| TYPE | YEAR | PROJECT NO. | SHEET NO. |
|---|---|---|---|
| R.O.W. | 2015 | HSIP-106(33) | 4A |

STATE OF TENNESSEE
DEPARTMENT OF TRANSPORTATION

# PROPOSED LAYOUT

STA. 104+43 TO STA. 117+00

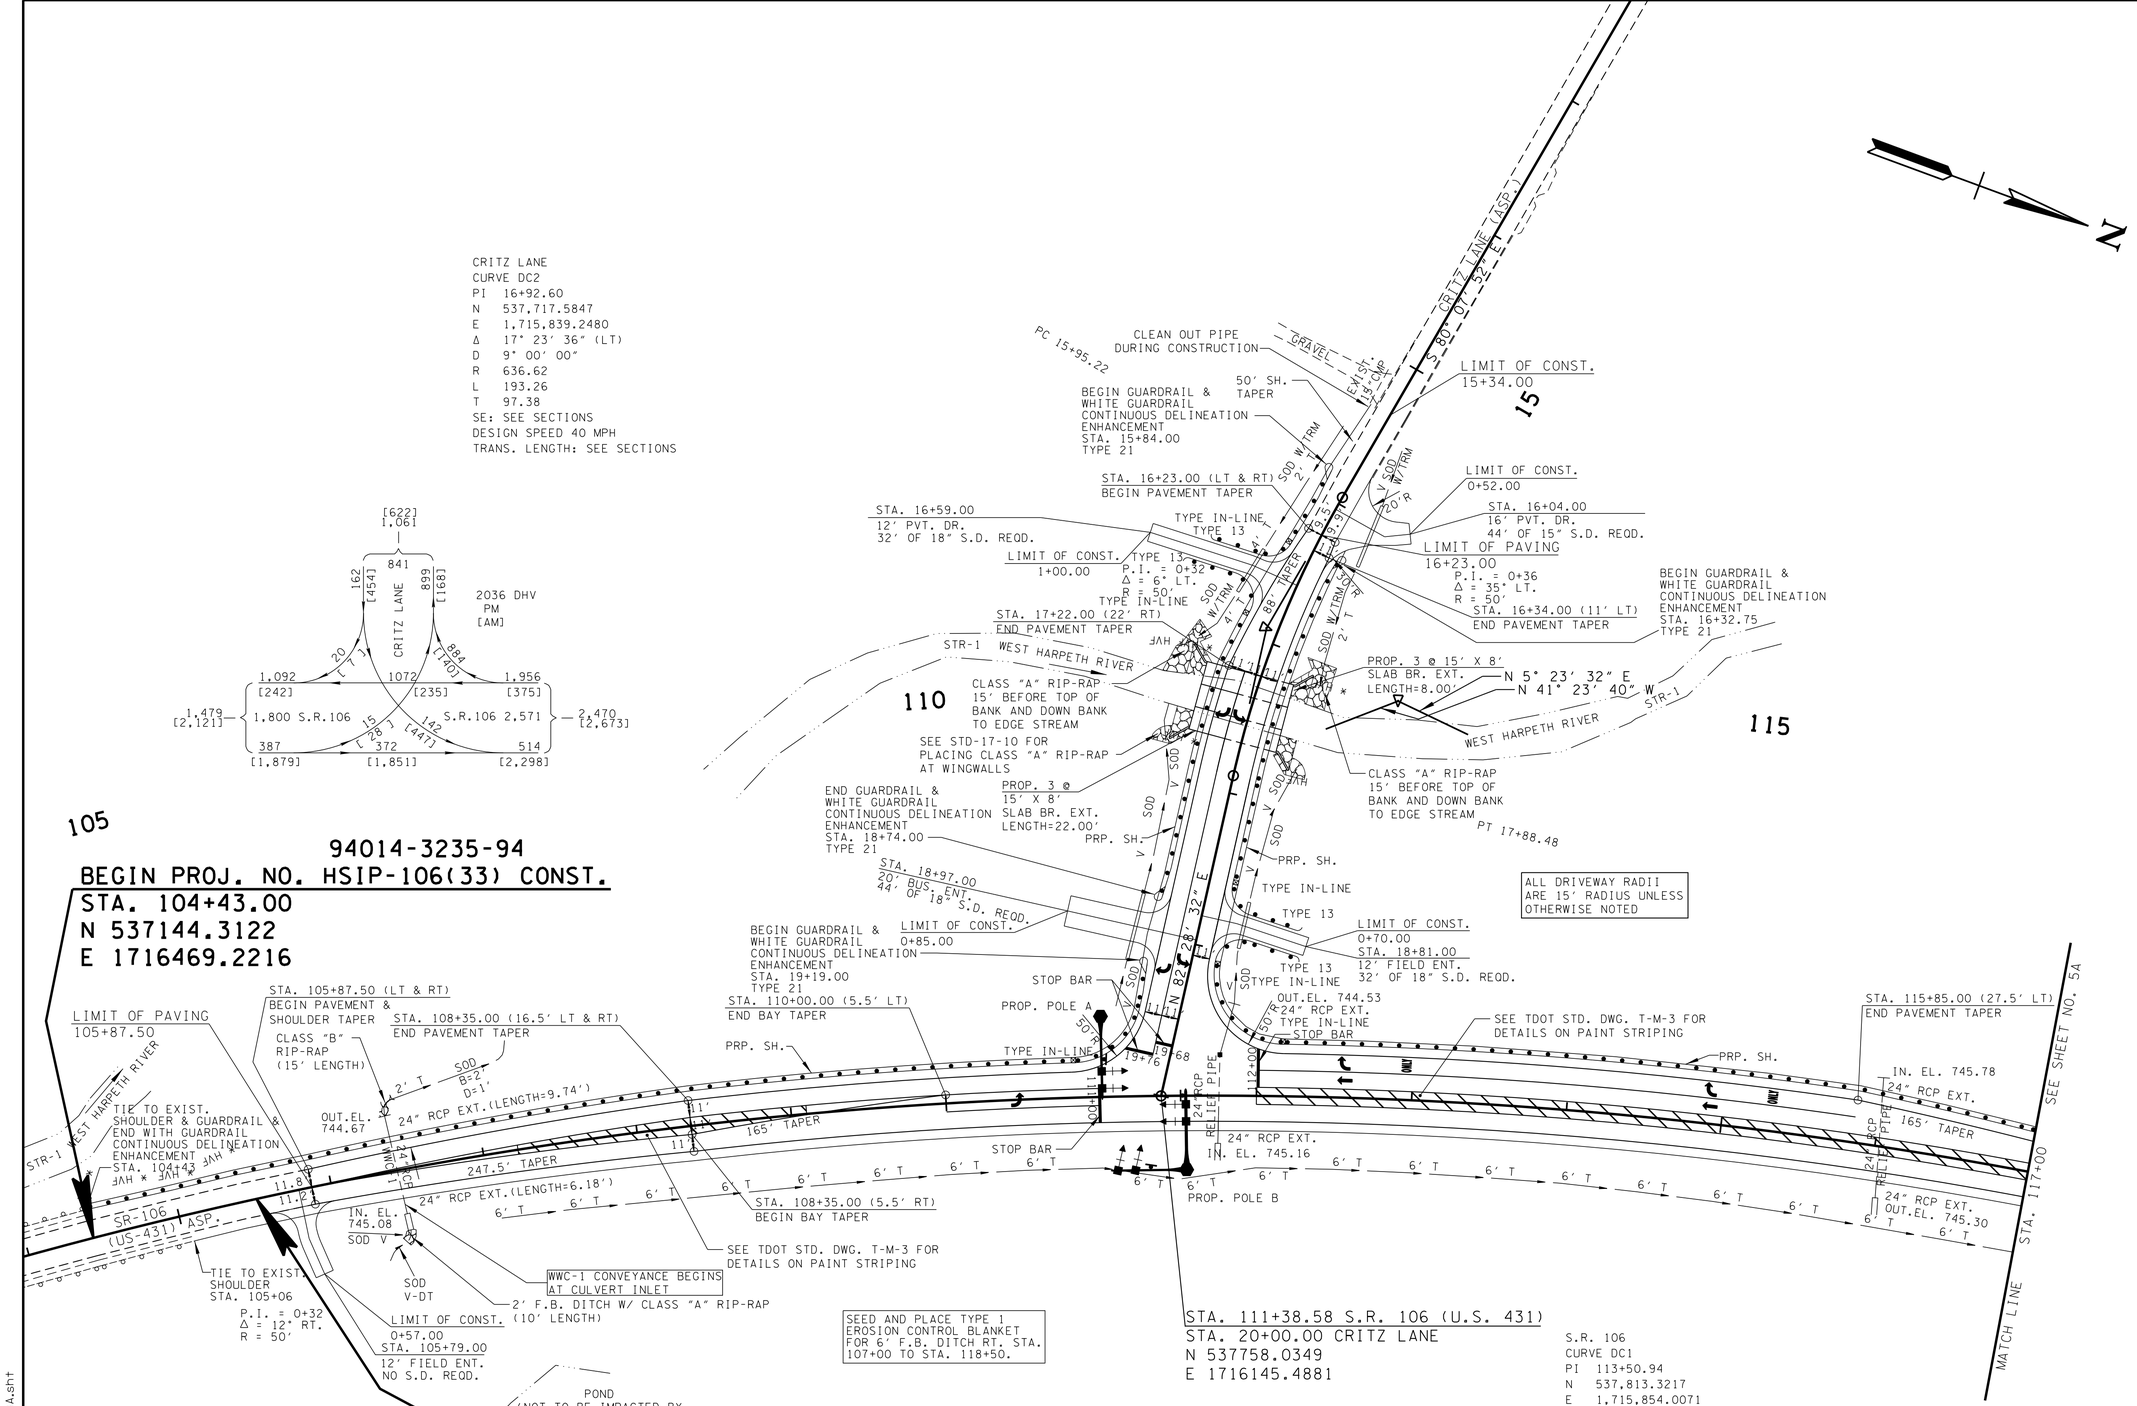
REV. 9-22-16: ADJUSTED PROPOSED V-DT RT. CRITZ LANE STA. 18+00 TO 19+50. MOVED 20' BUS. ENT. FROM STA. 18+82 TO 18+97 RT AND MOVED TYPE 21 END TREATMENTS AT ENTRANCE. REDESIGNED TRAFFIC SIGNALS AT INTERSECTION OF SR-106 AND CRITZ LANE FROM USING STRAIN POLES TO USING MAST ARM POLES.

REV. 12-08-16: ADJUSTED DITCHES AND REMOVED GUARDRAIL RT. STA. 106+00 TO RT. STA. 117+00.

REV. 02-20-17: ADJUSTED DITCHES, SIDE DRAIN, AND PRIVATE DRIVE WIDTH LEFT STA. 16+04.
